**NBHC APPLICATION**  
384 Acushnet Avenue  
Door Replacement

**CERTIFICATE OF APPROPRIATENESS:**

Replacement of double door with single wood door and side transom.

## STAFF COMMENTS

**A1.0.1 EXTERIOR ELEVATION**  
SCALE: 3/4" = 1'-0"

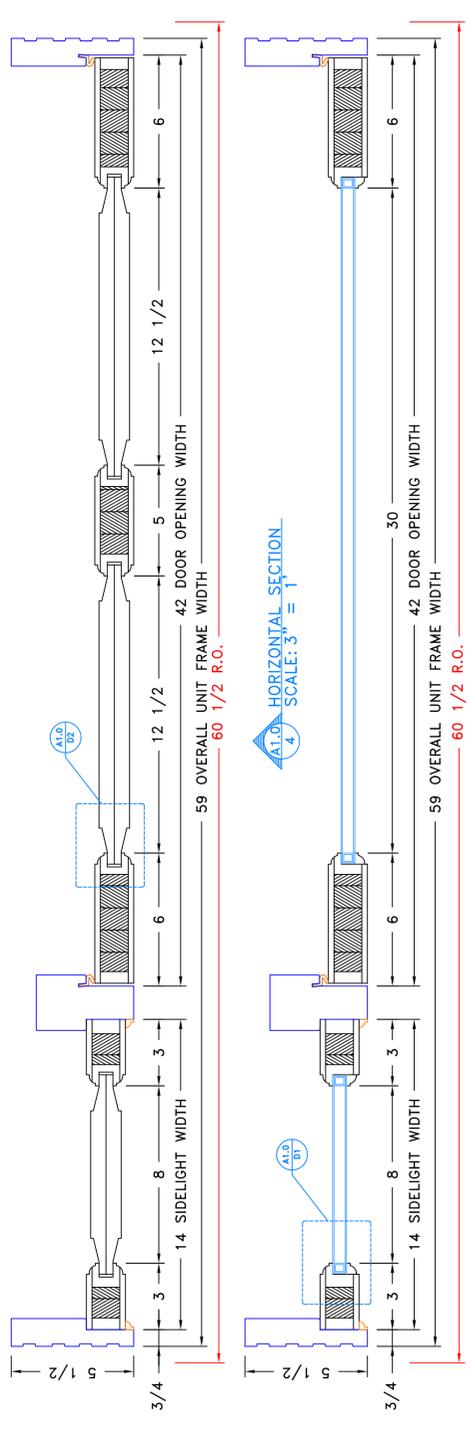
**CUSTOMER TO CONFIRM PANIC PREP W/ ELECTRIC STRIKE**

- The proposed single door allows for better egress and fulfills the life safety code requirements with the use of an interior panic bar.
- There are no specifications for exterior door hardware. Modern hardware style and finishes should be sensitive to the age and character of the building and Commission members may consider requiring staff review of door hardware prior to installation.
- Specification that door be painted to match existing.

**STAFF RECOMMENDATION:** Although the proposed replacement door’s lower panels differ from the original door, it does match the existing adjacent doors. (see images) Because the single door and side transom match the material and design of the existing doorway, as well as the adjacent doors, the Certificate of Appropriateness should be granted.

Existing Double Doors

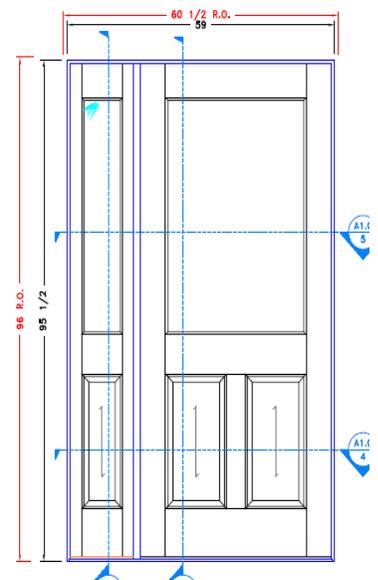
**EXISTING CONDITIONS:** The middle entrance consists of double wood doors with two lower raised panels in a horizontal position along with a glass panel. A large glass transom exists above the door jamb.

**PROPOSAL:** Replacement of the existing double doors with a single, custom-made solid wood constructed door with two lower raised panels in a vertical position along with a glass panel, as well as a side transom. The glass transom above the door jamb will not be altered.
